Office of General Services

ADDENDUM NO. 3 TO PROJECT NO. M3220

ELECTRICAL WORK PROVIDE EMERGENCY POWER IMPROVEMENTS, FARMINGDALE TRAINING SITE 25 BAITING PLACE RD FARMINGDALE, NY

August 13, 2026

E-102

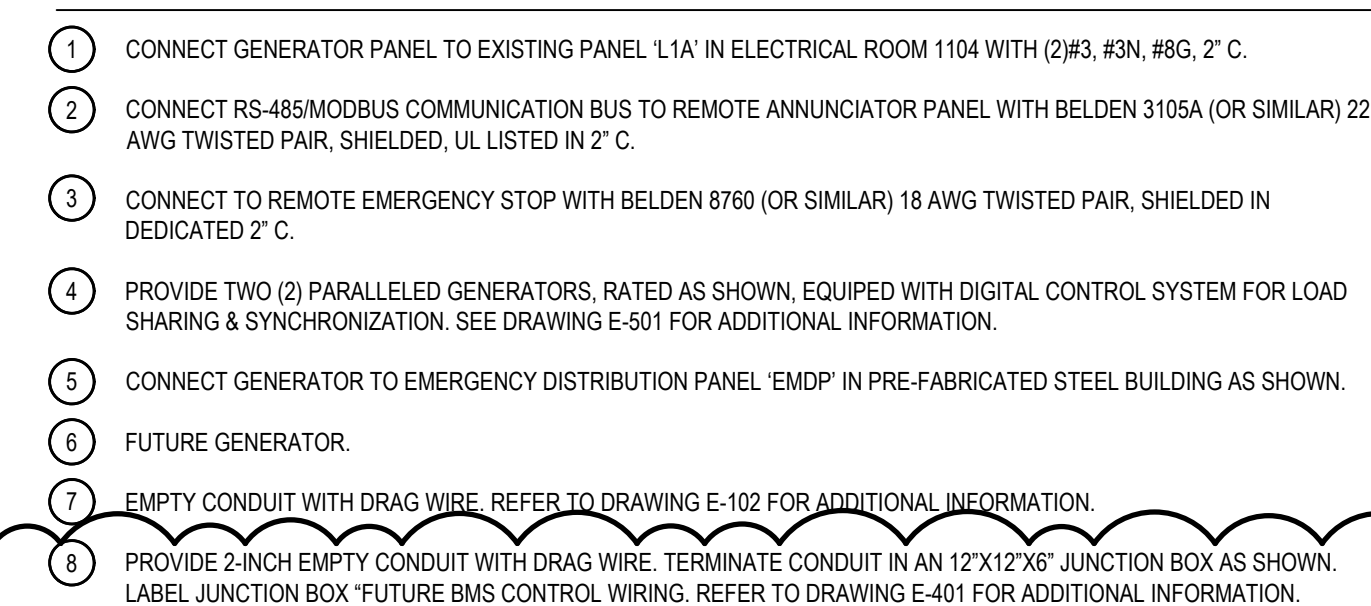
12. Revised Drawings:
 - a. Drawing Nos. E-102, E-401, E-601, E-602, noted Addendum 3, dated 8/12/2026, accompanies this Addendum and supersedes the same numbered previously issued drawings.
13. Addendum Drawing:
 - a. Drawing No. E-402, noted Addendum 3, dated 8/12/2026, accompanies this Addendum and forms part of the Contract Documents.
